East Anglia ONE North (EA1N)
East Anglia TWO (EA2)
Offshore Wind Farms

DEADLINE 4 COMMENTS ON THE APPLICANTS' DEADLINE 3 SUBMISSIONS

Interested Party: William Halford

East Anglia TWO and East Anglia ONE North Indicative cable trenching arrangement and working

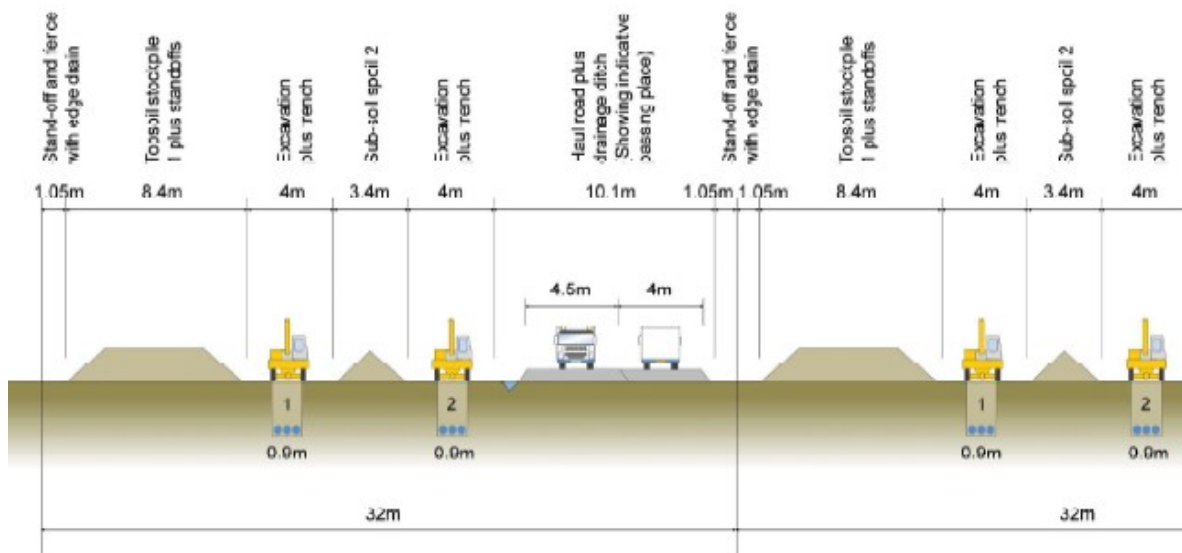
1. The document has not clarified the intended orientation of the cable corridors, for example: which of haul roads or cable trenches shall be the closer to the boundary of my home and others along the cable routes. This is important in evaluating the impact of construction noise and dust on residents close by.
2. This document does not clarify the Applicants' purpose in, or the need for, building two separate haul roads in the event that Scenario 1 prevails i.e. EA1N and EA2 constructed concurrently, as illustrated by SPR on the Display Boards at its formal Phase 4/Section 42 public consultation - Slide 2 of Appendix 9.10 of 5.1.9 Phase 4 Public Exhibition Boards [\[APP-038\]](#) :-
